## Annex X

## Test Specifications for Automated Lane Keeping Systems (ALKS)

5.5.1. Cut-In Tests

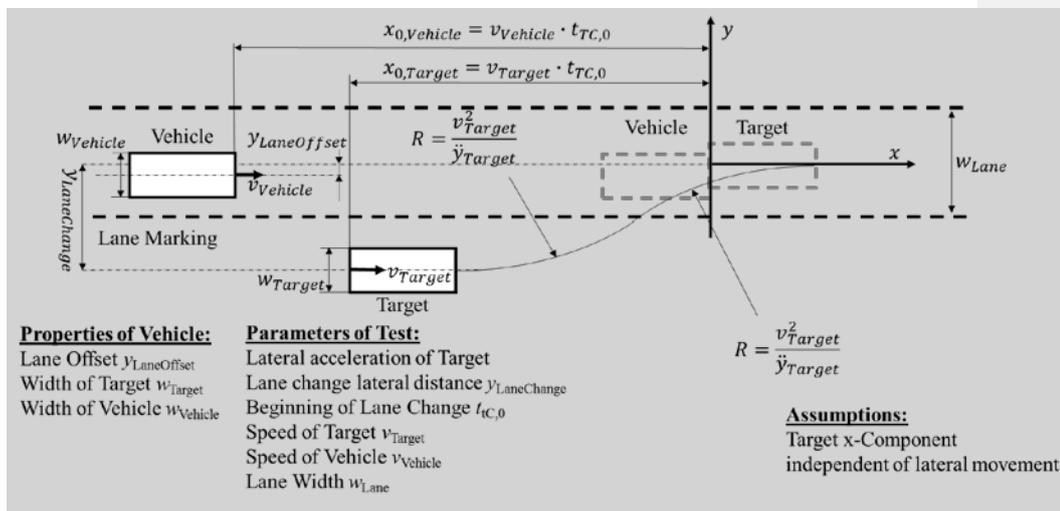
**Kommentiert [児島亨34]:** It is considered that Cut-In test is one of the test method in order to evaluate the capability of emergency manoeuvre. However, the parameters for the test is much more complicated compared to the Preceding vehicle severe braking test. Therefore, appropriate test procedure and parameters should be discussed carefully and justified.

5.5.2. Cut-Out Tests

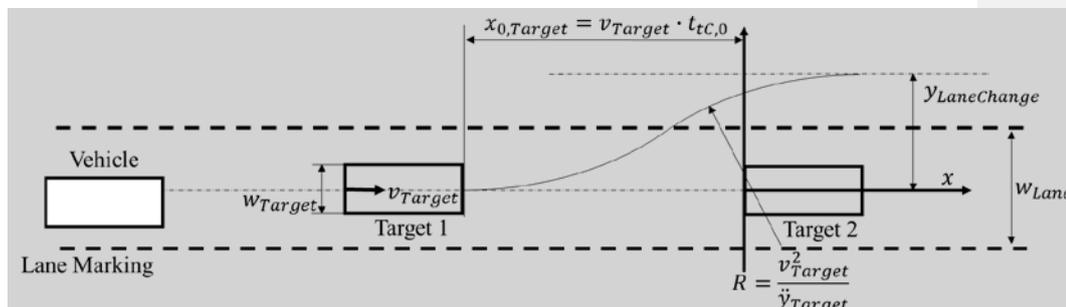
**Kommentiert [児島亨35]:** It is considered that Cut-Out test is one of the test method in order to evaluate the capability of emergency manoeuvre. However, the parameters for the test is much more complicated compared to the Preceding vehicle severe braking test. Therefore, appropriate test procedure and parameters should be discussed carefully and justified.
